**Petition No. 1395A
Windham Solar LLC
31 Benz Street, Ansonia**

**Partial Development & Management Plan II
Staff Report
October 18, 2024**

Site Layout

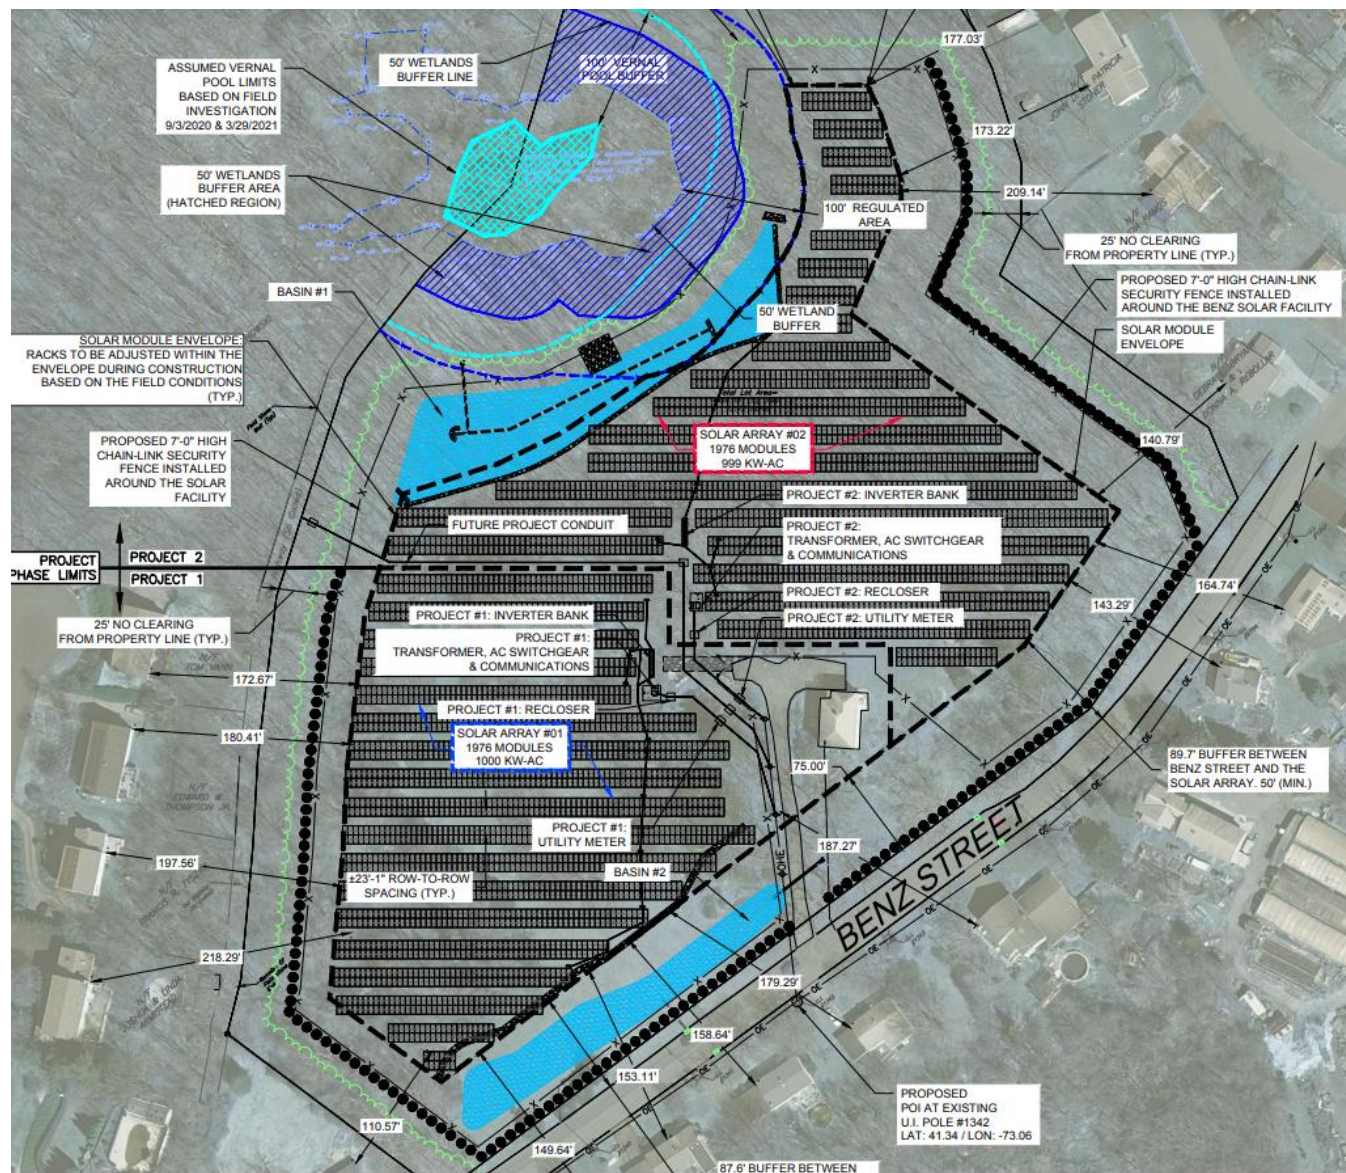
Due to a redesign of the electrical interconnection, WS plans to relocate the eastern transformer/switchgear/inverter pad to a location northwest of the on-site building and consolidate the two approved overhead interconnection lines (one for each solar array), to one interconnection line located along the existing driveway to the on-site building. The revised interconnection would require 4 utility poles to conform to the United Illuminating Company's technical design standards and would support a GOAB, recloser and disconnect switch. Customer-side meters and reclosers will be pad-mounted.

The higher wattage solar modules and electrical interconnection redesign will be located within the approved limit of disturbance (LOD). No revisions to the DEEP Stormwater Permit are required.

Details regarding emergency evacuation of the sheep remain outstanding.

1. Provide details for emergency evacuation of the sheep; and
2. Install signage on the solar facility site perimeter fence with contact information for the sheep grazer.
